CITRUS COUNTY CENTRAL LANDFILL SITE ASSESSMENT REPORT IN ACCORDANCE WITH CHAPTER 62-780.600(8) FAC

RESPONSE TO FDEP REQUEST FOR ADDITIONAL INFORMATION

January 2009

Figure 4: LandGEM output showing the estimated gas production at the Citrus Central Closed Landfill.

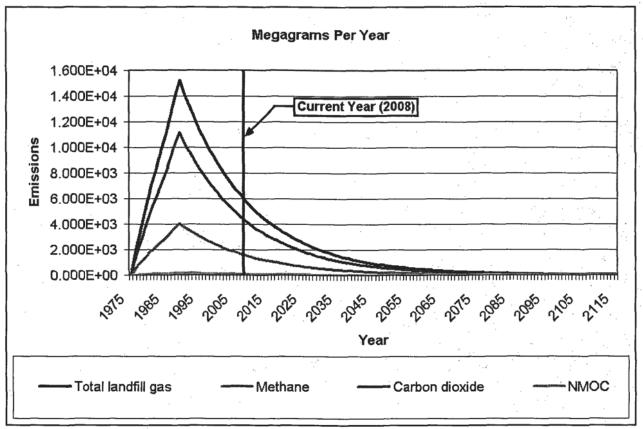
Comment 2: The monitoring data reported through the January/March 2008 sampling events do not show an overall decrease in contamination, as required by Rule 62-780.690(l)(e), F.A.C.

Previous study has indicated that the primary mechanism of transport for the contamination detected in MW-10 is landfill gas. The constituents of concern detected in MW-10 are Benzene and Vinyl Chloride. However, the other VOCs detected in MW-10, such as 1,4-Dichlorobenzene and cis-1,2-Dichloroethene, are also diagnostic of landfill gas impacts at the well. Figure 3 is a graph of the trends of Vinyl Chloride and

While the geochemical data for the short period available from MW-10 do not indicate a downward trend, the standard models for landfill gas production indicate that the source of the contamination has been decreasing since the closure of the site.

Figure 19-1 Cross-Section between MW-11 and PZ-2 at the Citrus Central Landfill

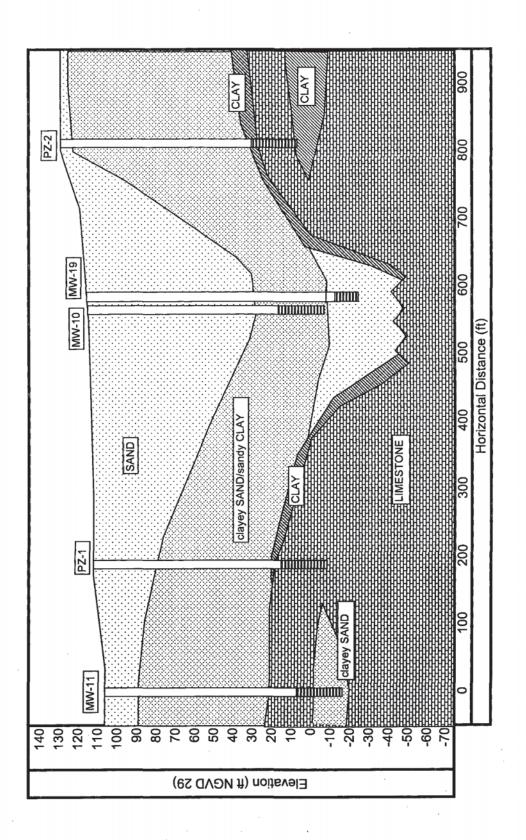
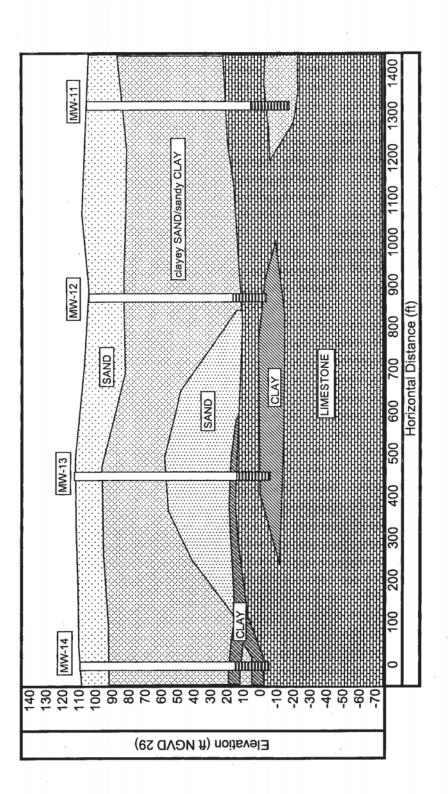
Comment 19: Figures 17-1 and 17-2 appear to depict the contact between the sand/clayey sand sediments and the limestone sediments based on the first occurrence of limestone. These figures do not depict the stratigraphy encountered at MW-11, MW-12, MW-13 and PZ-2 where clayey sand, sandy clay, silty clay, or clay were reported below the uppermost limestone.

Response 19: The figures were created to show the highly irregular limestone contact observed across the site. Attachment 19 includes two cross-sections, one from the western boundary and one from the assessment area around MW-10 looking north. These cross-sections display a finer detail than those submitted in the original SAR document.
